Fwd: CH 25 comments

From: Hannes Stueckler <hannes.stueckler@wyo.gov>
Date: Mon, Feb 4, 2013 at 5:07 PM
Subject: CH 25 comments
To: William Tillman <william.tillman@wyo.gov>

To: Bill Tillman
 From: Ronald Ewald, Assistant Southeast District Engineer
 Water Quality Division, Wyoming DEQ
 Date: February 27, 2013
 Subject: **DRAFT2 Chapter 25 – Comments, Questions, and Concerns**

FIGURE 1

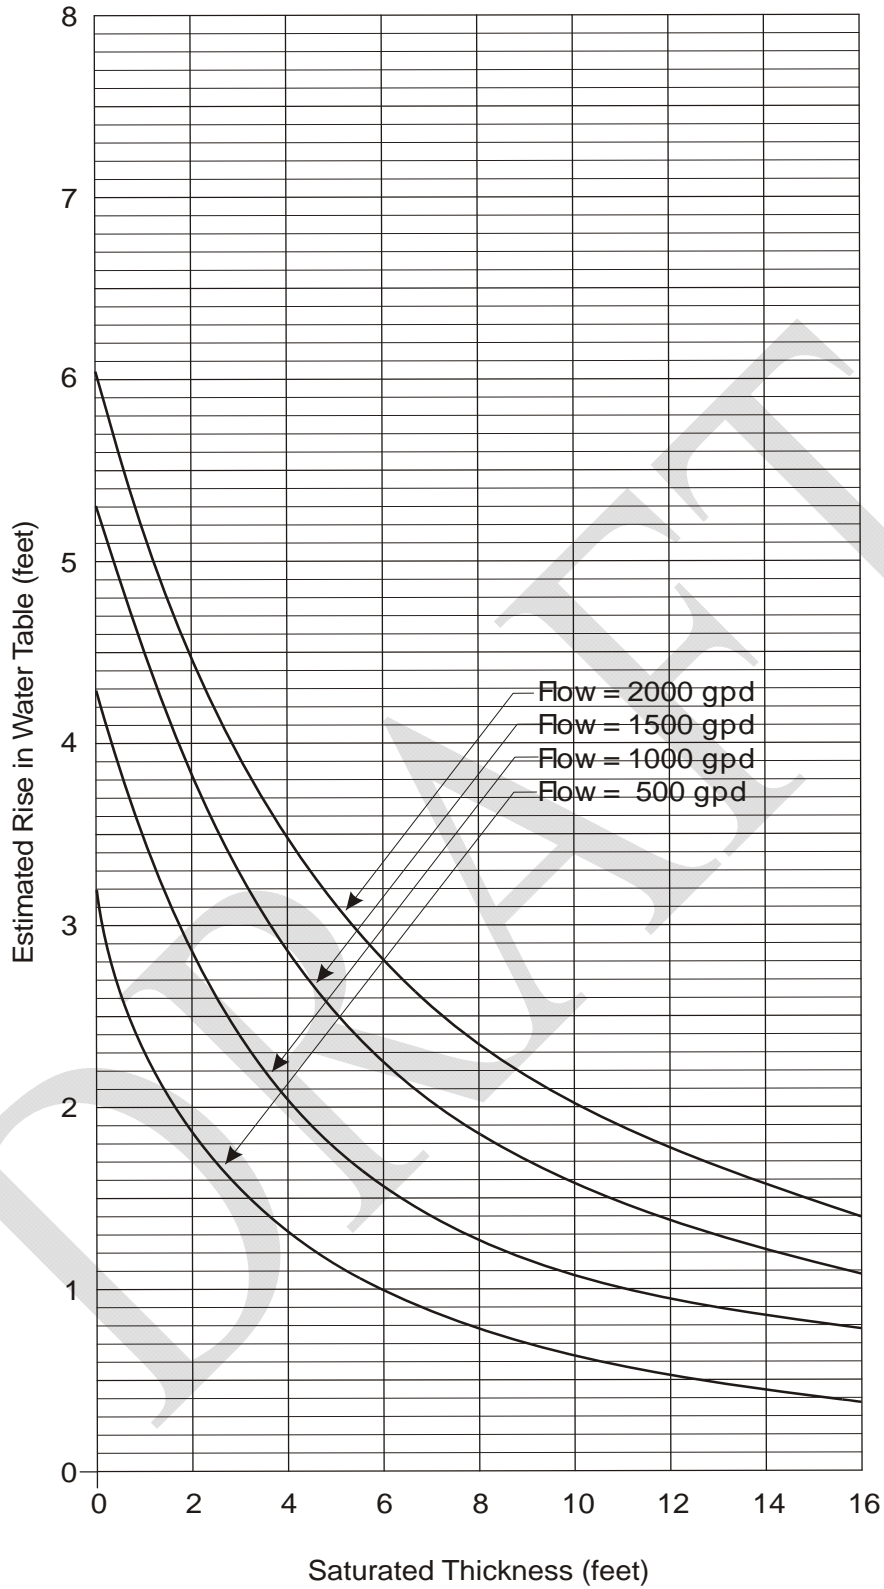
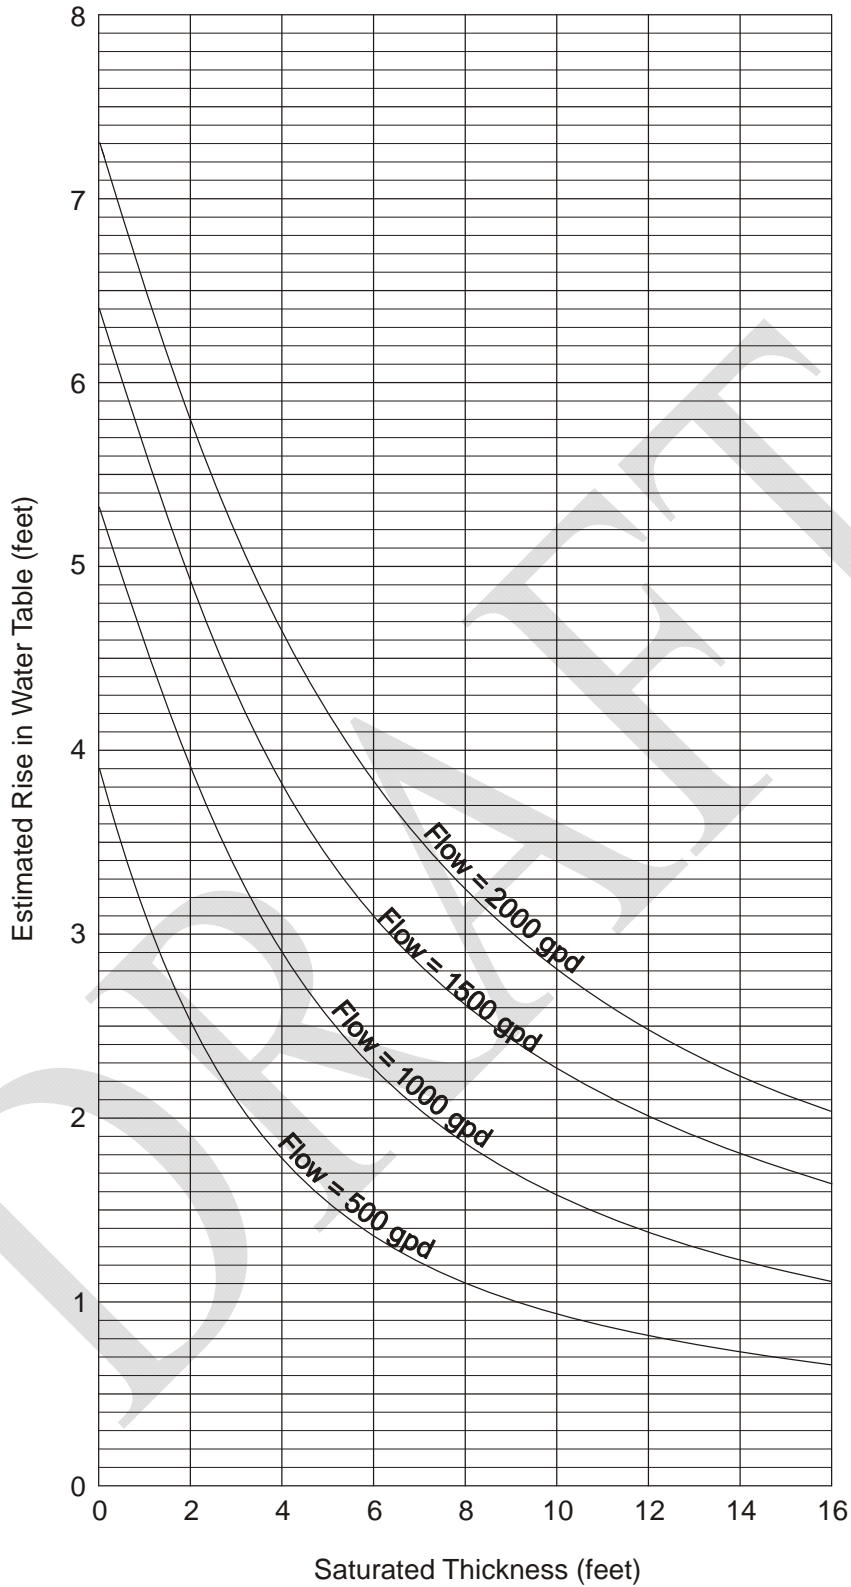
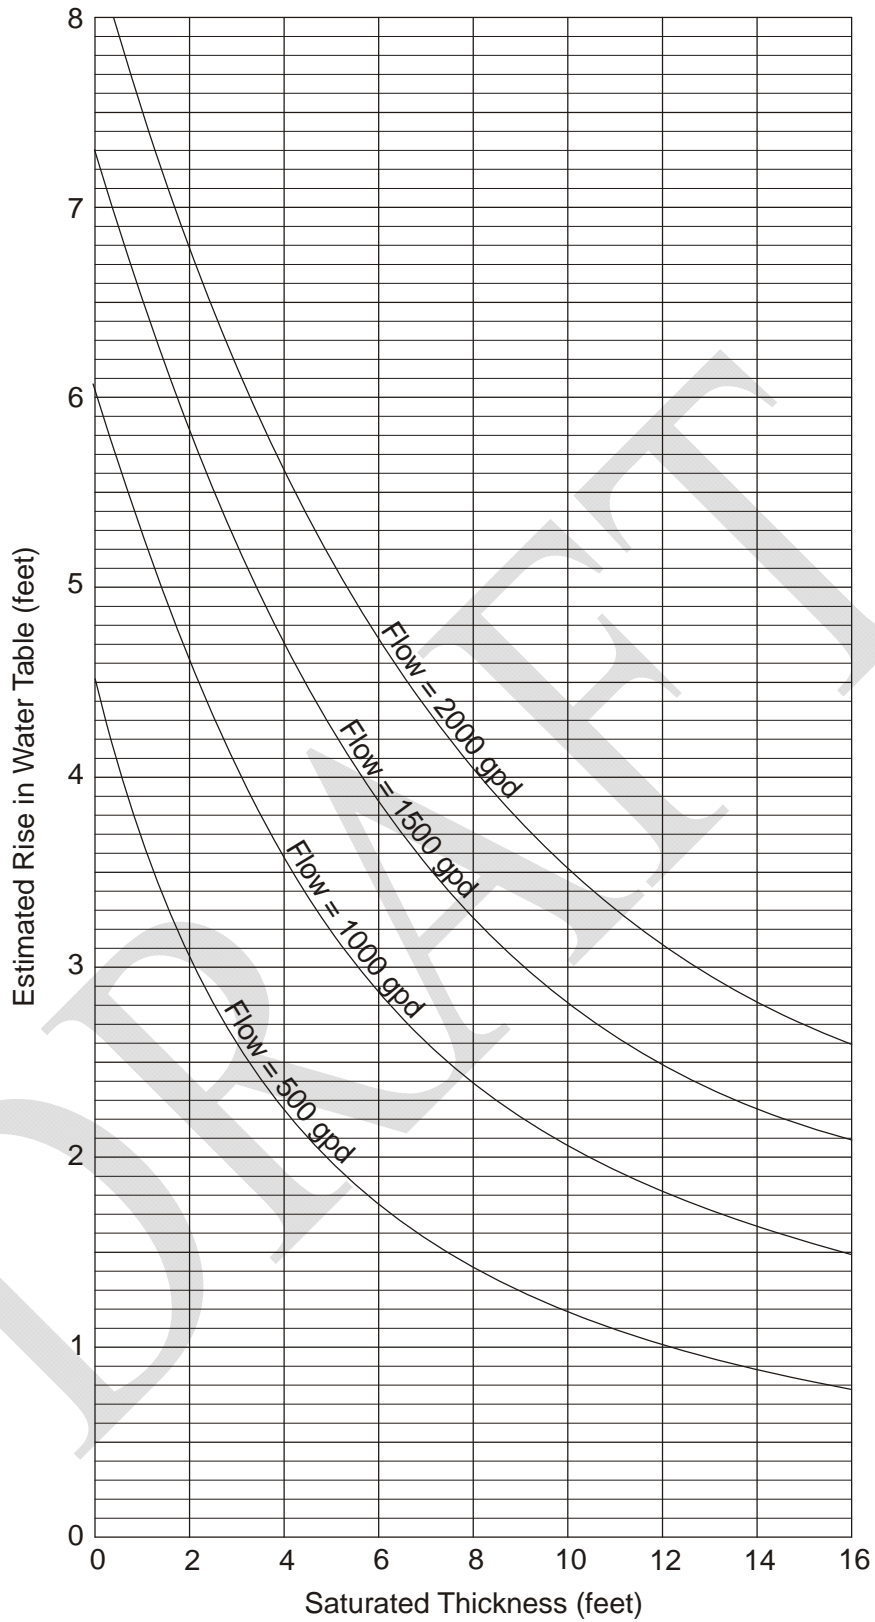
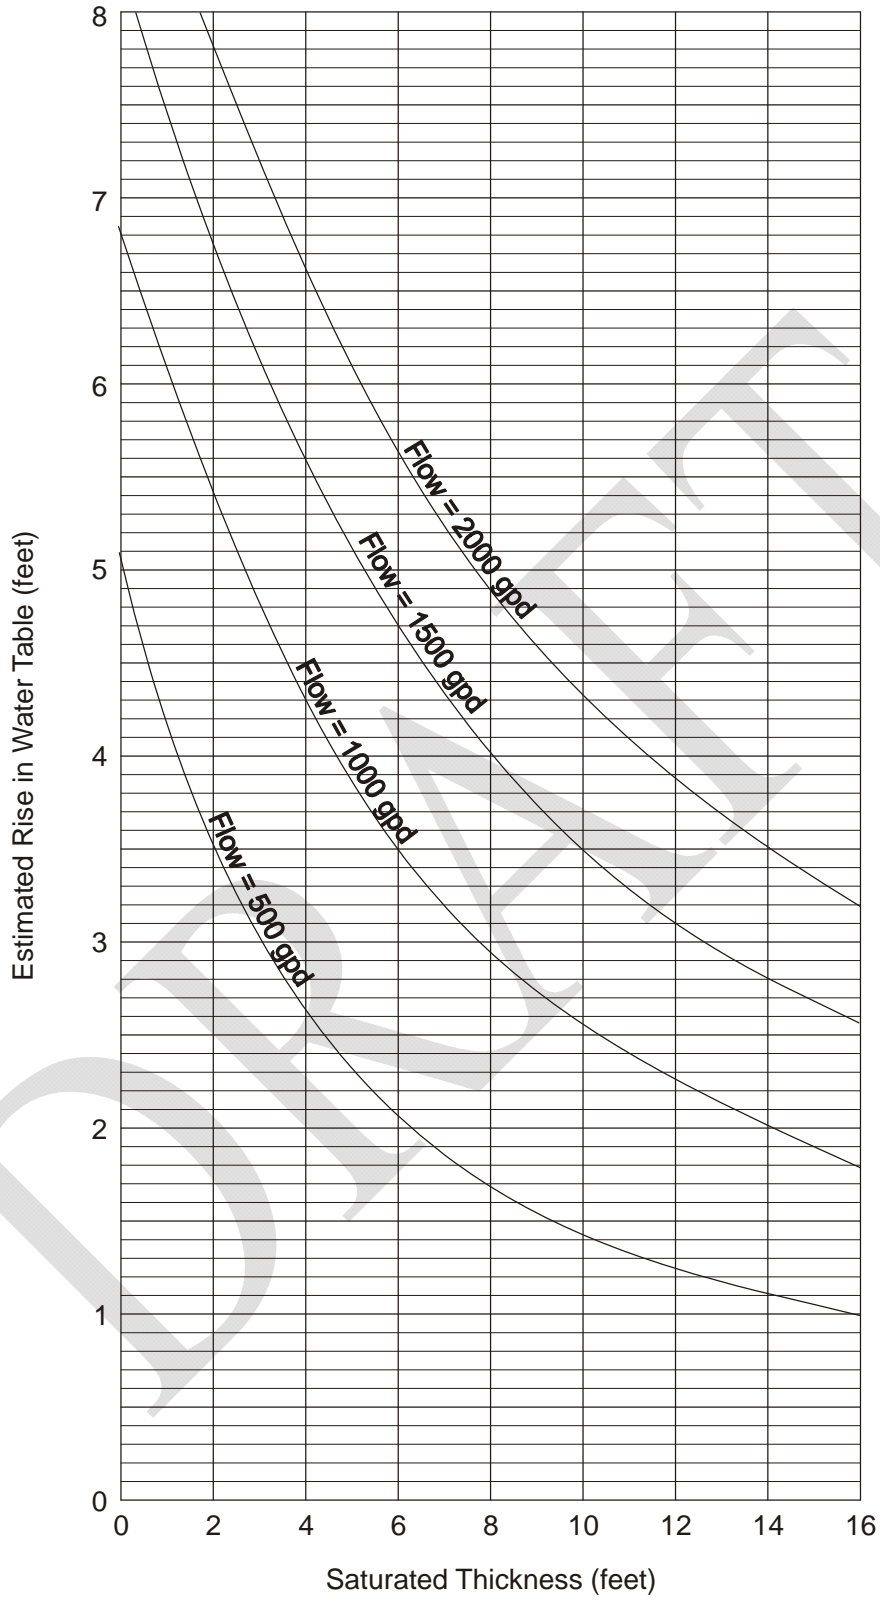
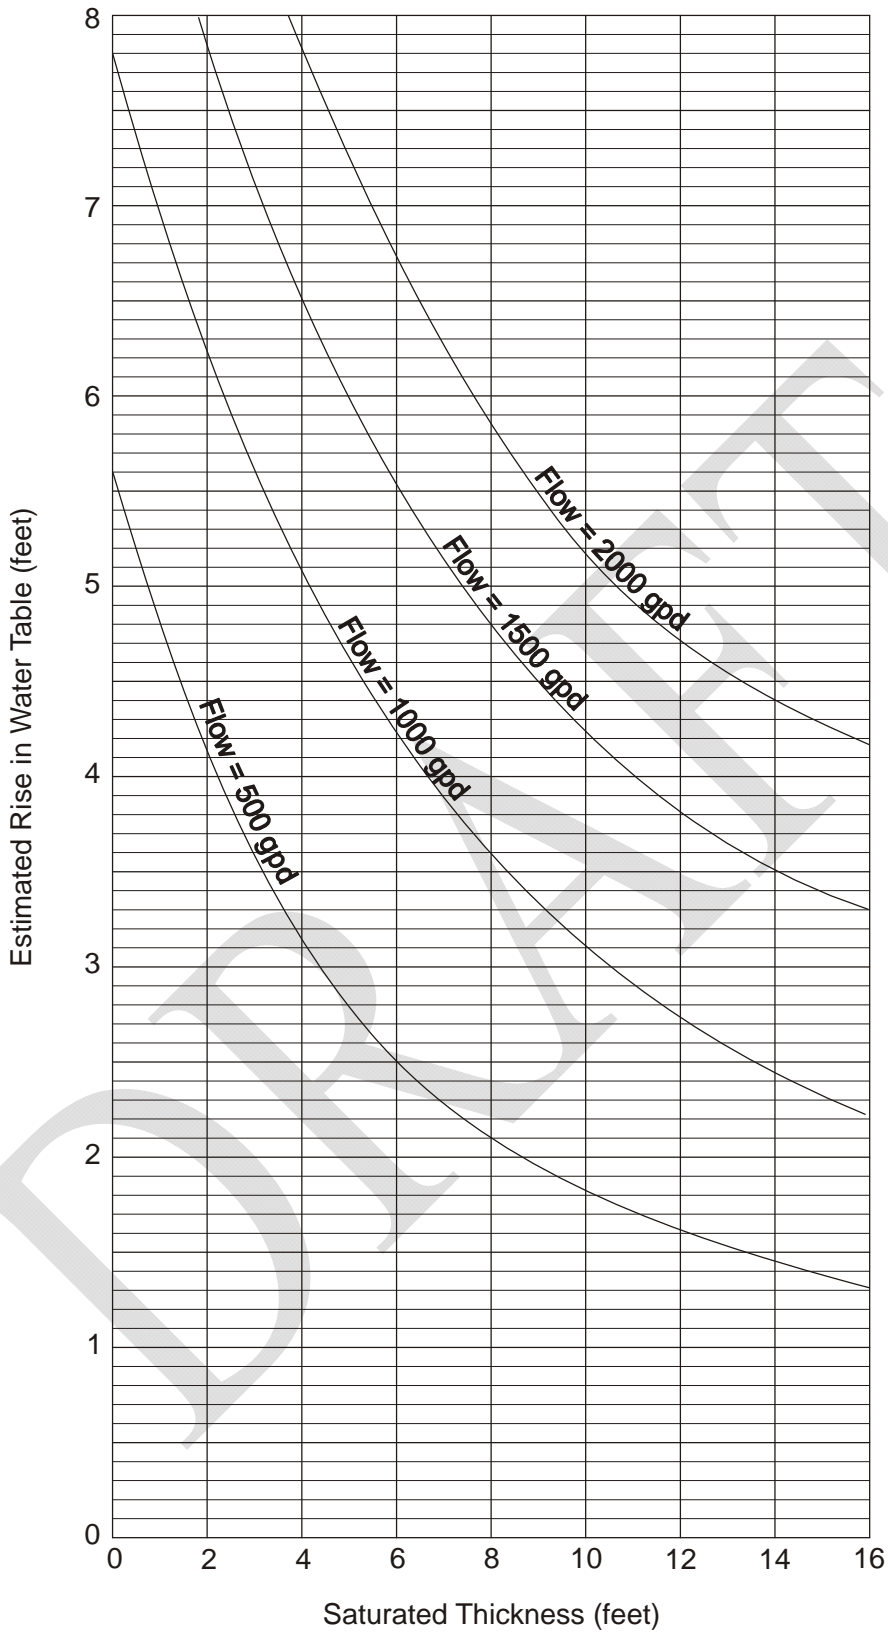
- Figure 1-6: Since these regulations are intended for use by non professionals, I think you should define “saturated thickness”.
- Table 4. Minimum horizontal setbacks from public water supply wells of 500 feet for septic tank and 1000 feet for absorption system could be impossible for some transient public water supply systems, seems excessive for a system under 2000 gpd, doesn’t take into account the vertical unsaturated separation, nor the treatment level that could be provided by an advanced system.
